Docket No.: 50-302

CRYSTAL RIVER UNIT 3 NUCLEAR GENERATING PLANT
AMENDMENT TO FACILITY OPERATING LICENSE

Amendment No. 19
License No. OPR-72

ATTACHMENT TO LICENSE AMENDMENT NO. 19

FIGURE 2.1-1

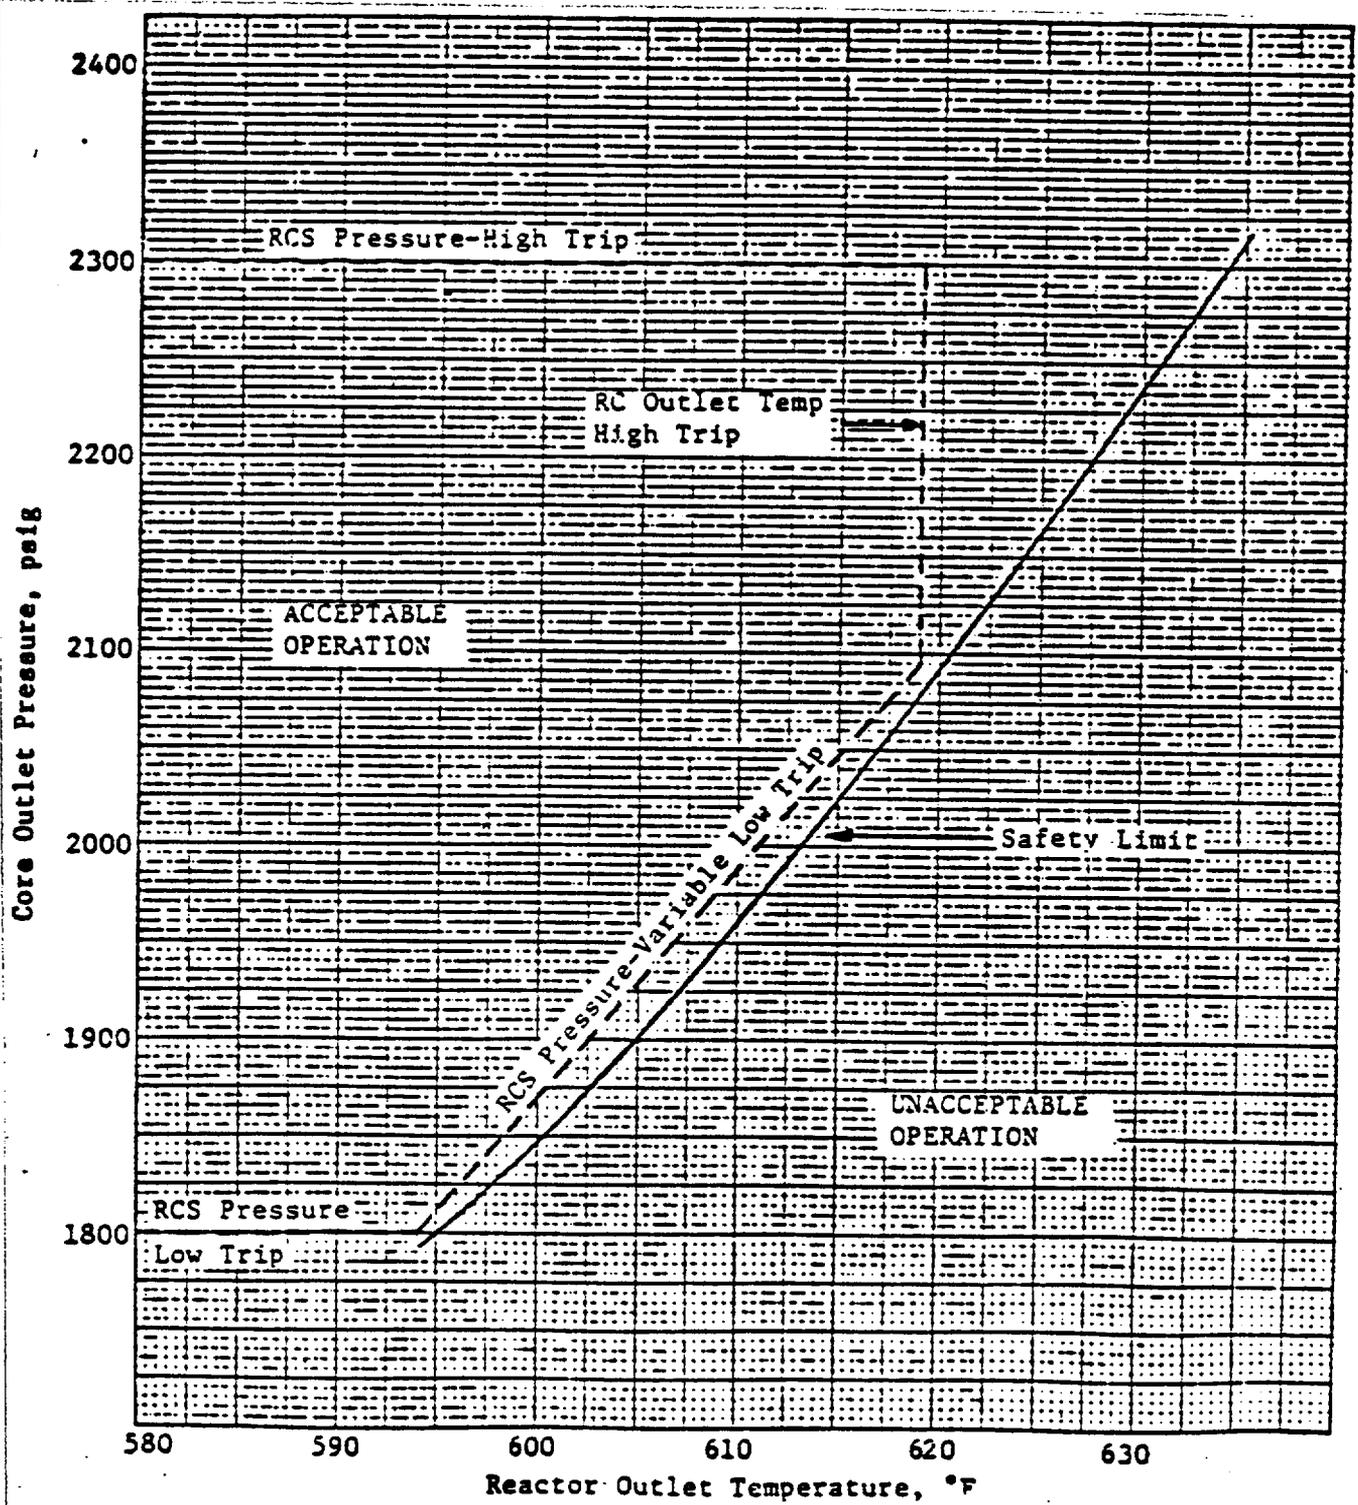
The curve presented in Figure 2.1-1 represents the conditions at which a minimum DNBR of 1.30 is predicted for the maximum possible thermal power 112% when the reactor coolant flow is 139.86×10^6 lbs/hr, which is 106.5% of the design flow rate for four operating reactor coolant pumps. This curve is based on the following nuclear power peaking factors with potential fuel densification effects:

Figure 2.1-2
Reactor Core Safety Limit

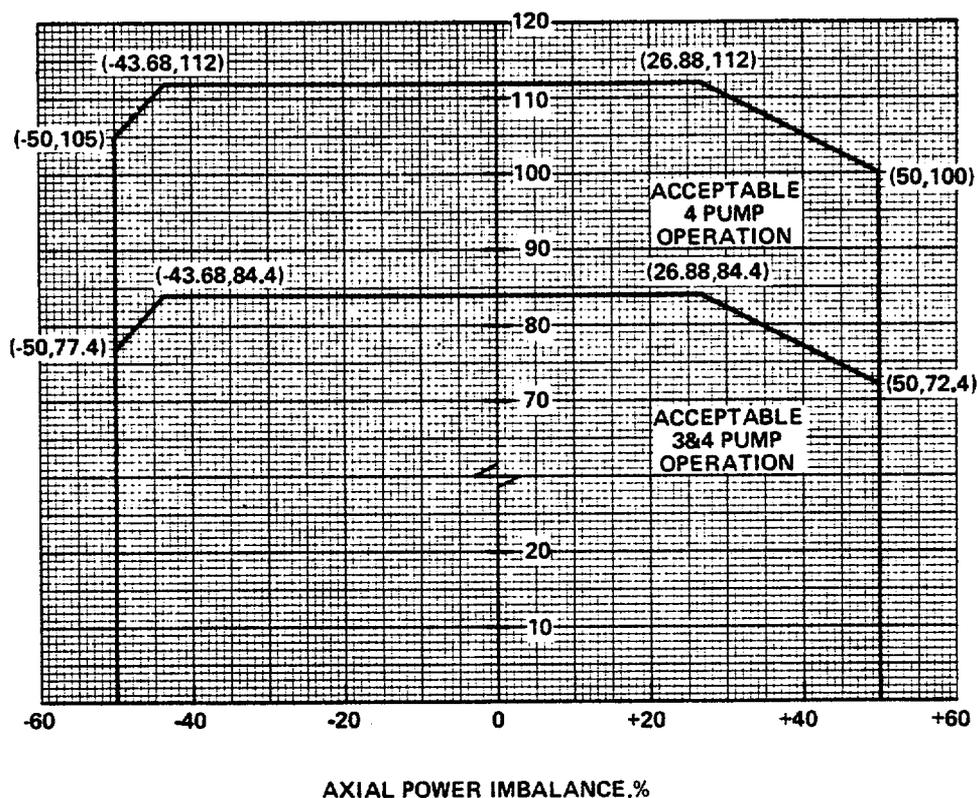
The curves of Figure 2.1-2 are based on the more restrictive of two thermal limits and account for the effects of potential fuel densification and potential fuel rod bow:

The specified flow rates for curves 1 and 2 of Figure 2.1-2 correspond to the expected minimum flow rates with four pumps and three pumps, respectively.

Figure 3.1-1
Regulating Rod Group Insertion Limits For 4 Pump
Operation From 0 EFPD To 233 ± 10 EFPD

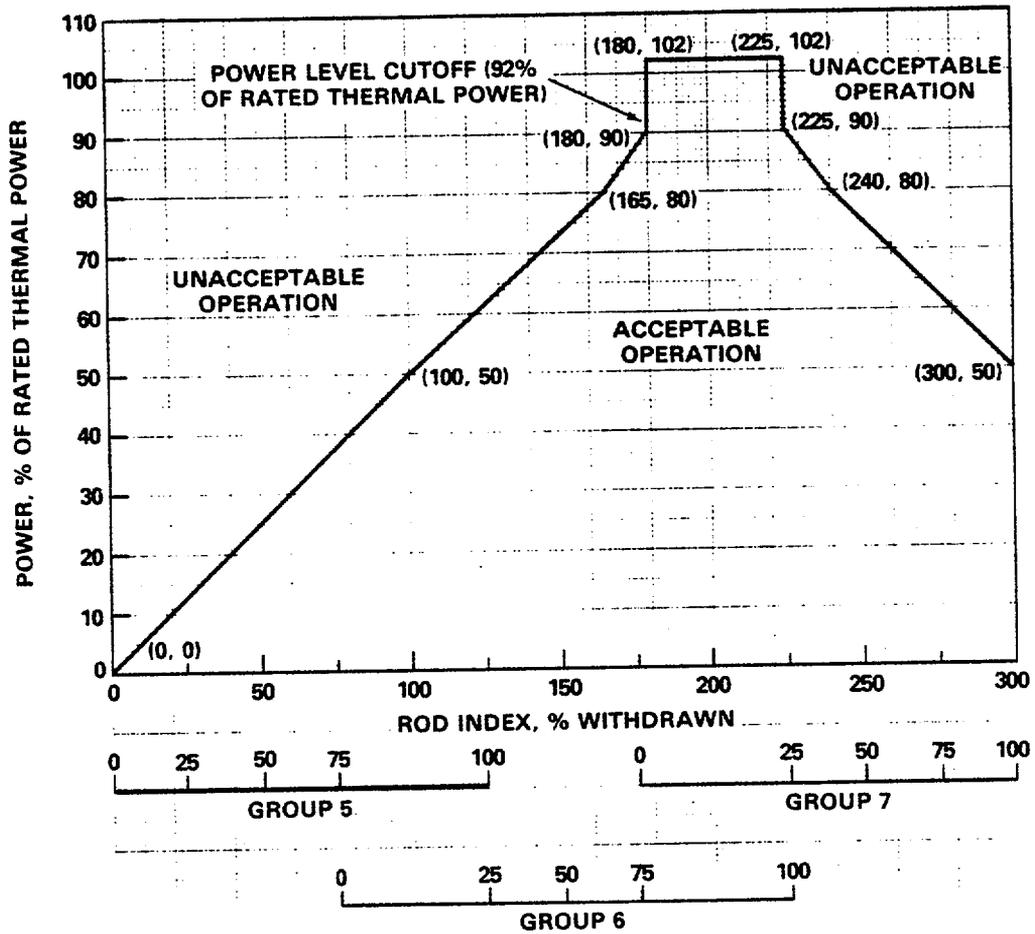
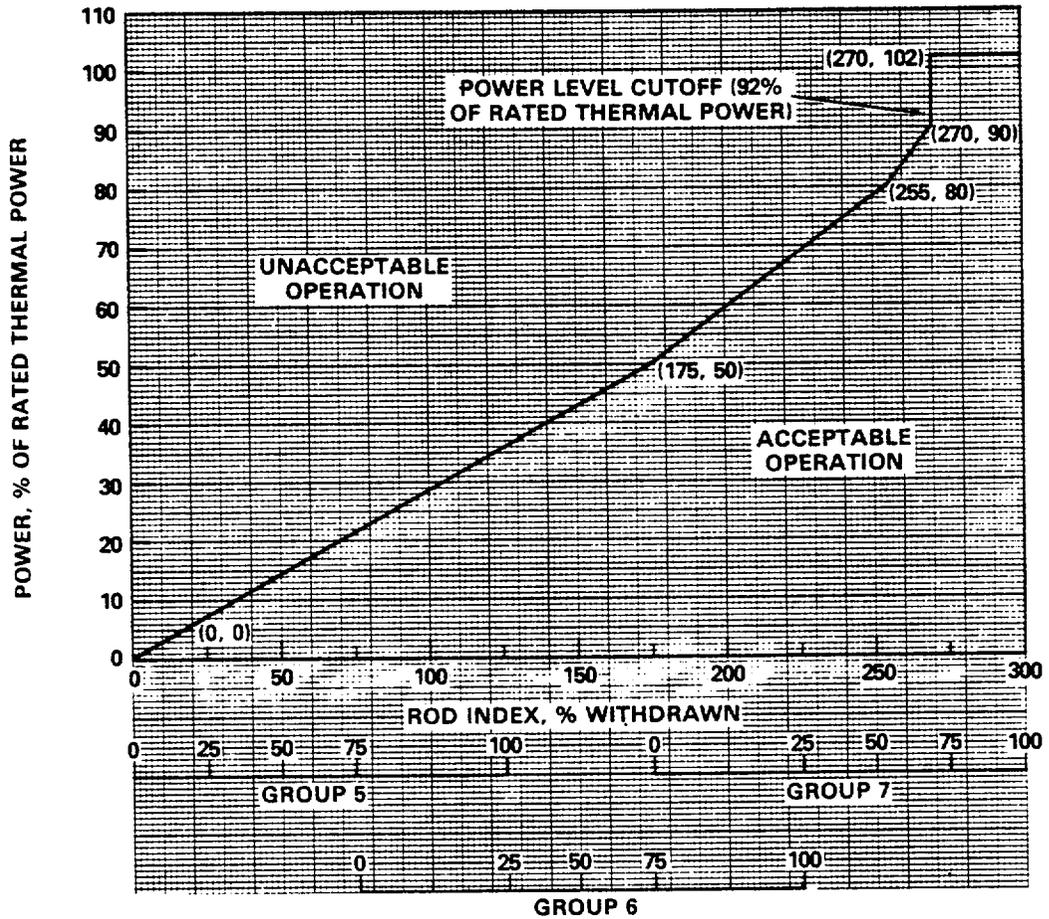
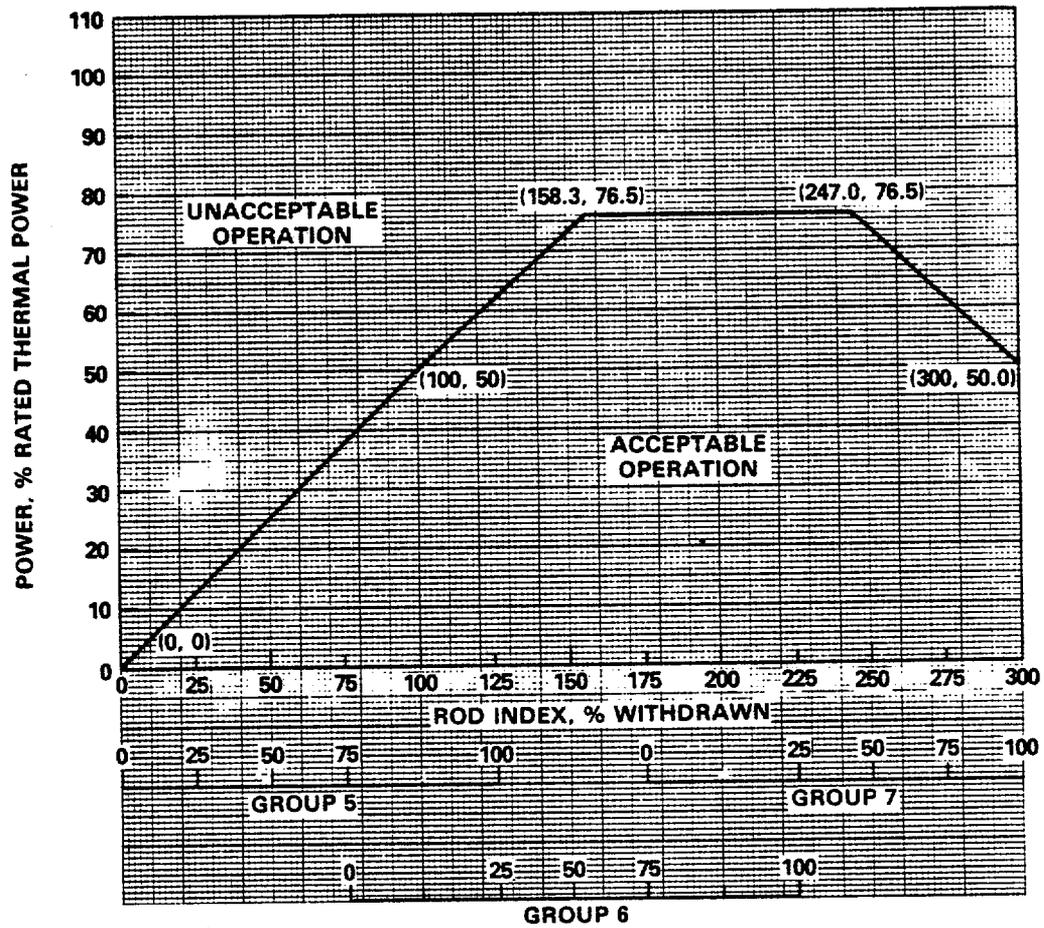
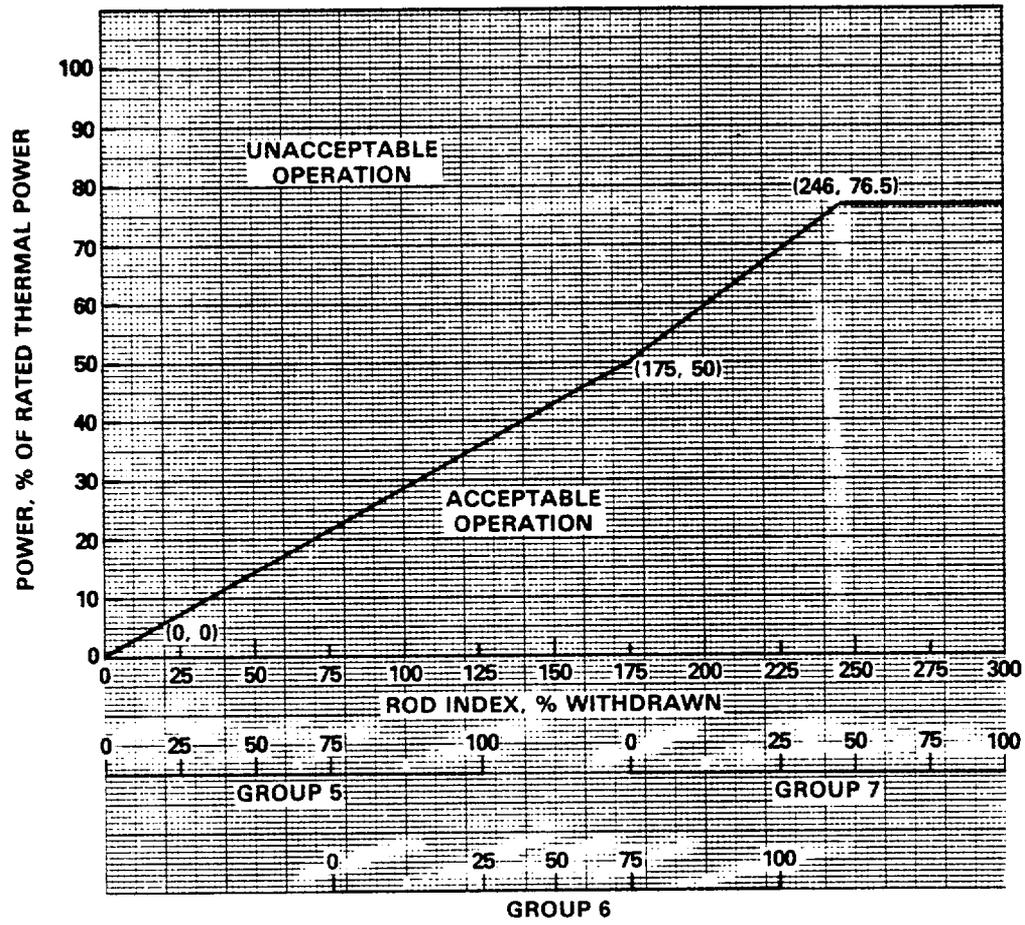
- (6) Table 3.2-1 would reflect the increased assumed flow.
- (7) Table 3.2-2 would show error-adjusted limits to reflect the age of detectors.
- (8) Regulating rod group insertion limits for 3 and 4 pump operation, and the axial power shaping and position limits would be provided for operation less than 233 ± 10 EFPD and for operation more than 233 ± 10 EFPD. The 233 EFPD is the latest time in Cycle 2 at which the transient bank is nearly full-in at power level of 2452 MWt.

Figure 3.1-9
 Axial Power Shaping Rod Group Insertion Limits
 From 0 EFPD To 233 ± 10 EFPD

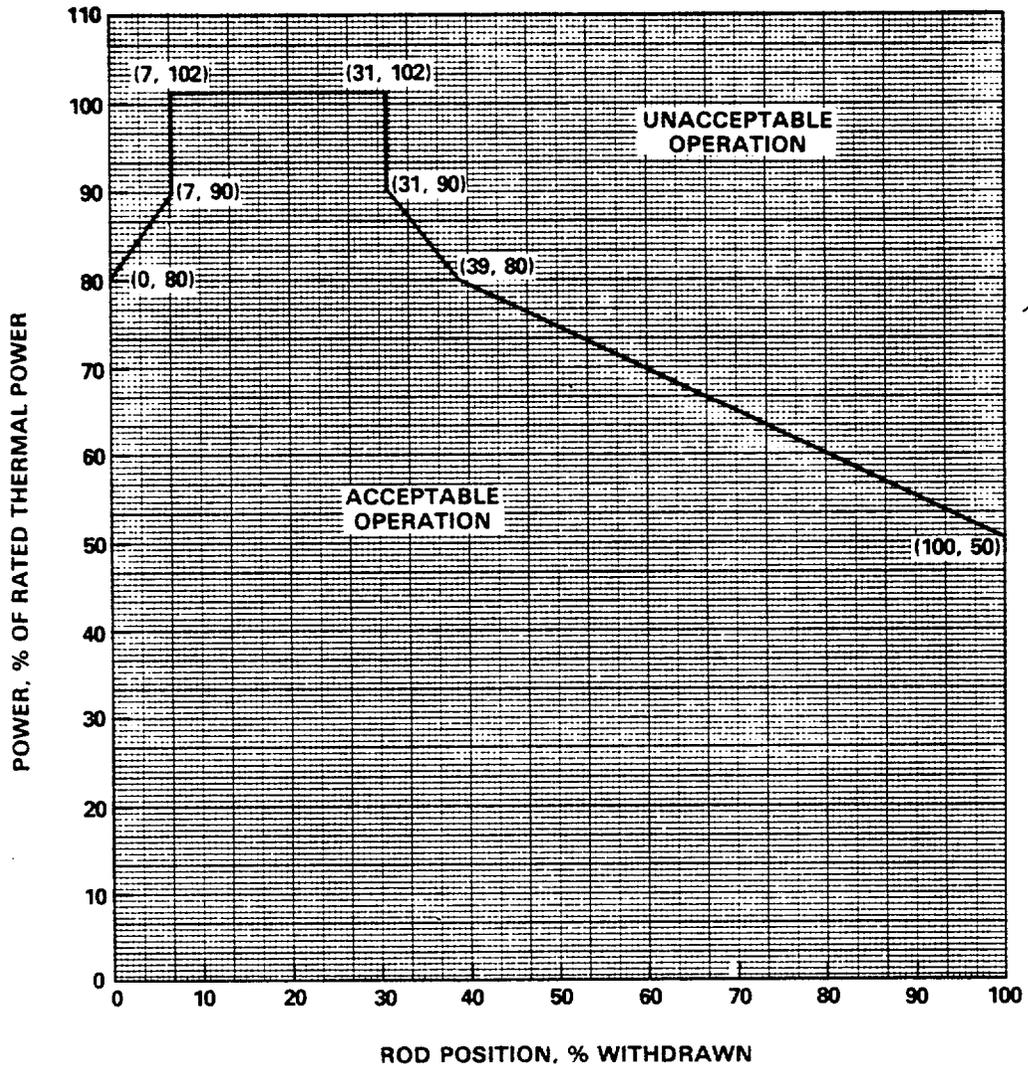
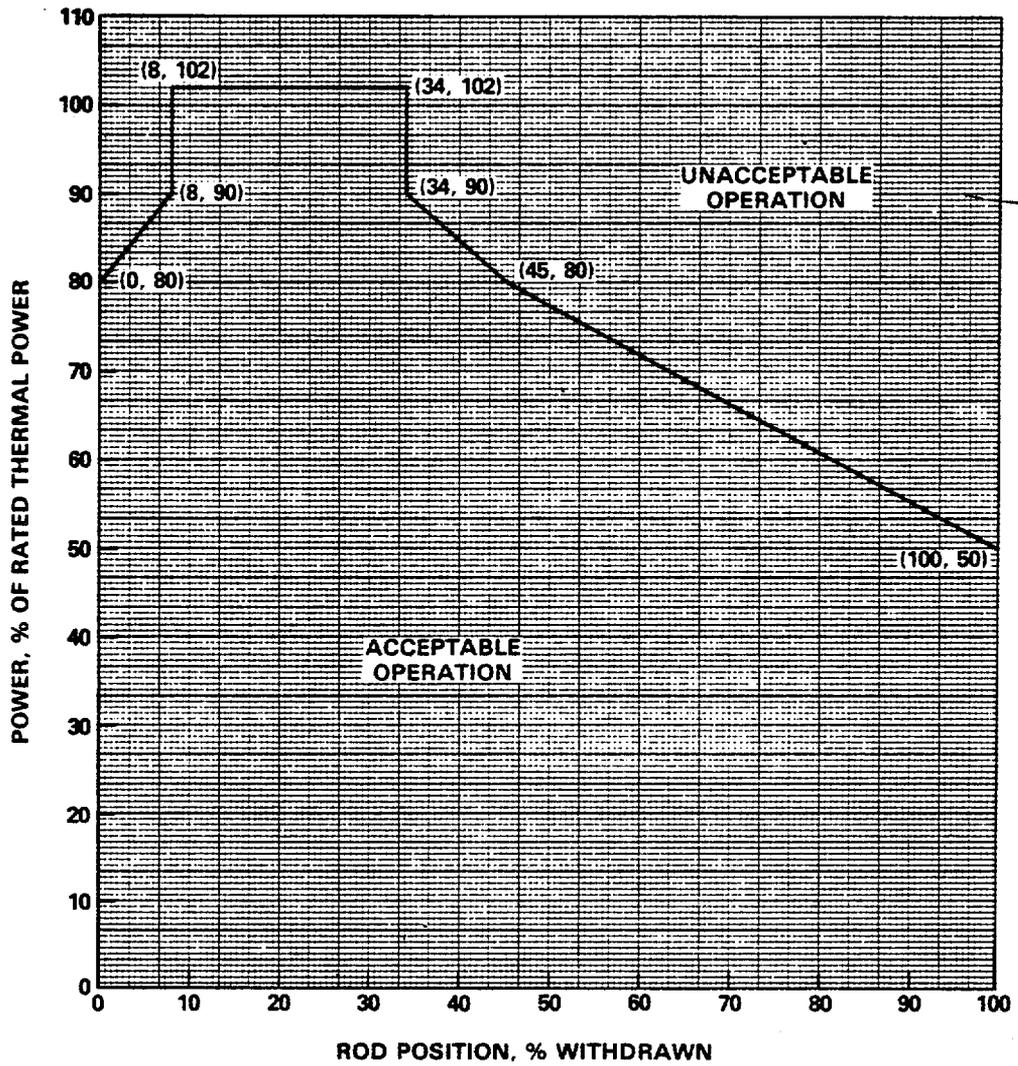
- (4) Specifications 3.1.3.6, 3.1.3.7, 3.1.3.9, and 3.2.1 would reflect revised nuclear parameters as a result of the Cycle 2 reload.
- (5) Table 2.2-1 would reflect the increased assumed flow.
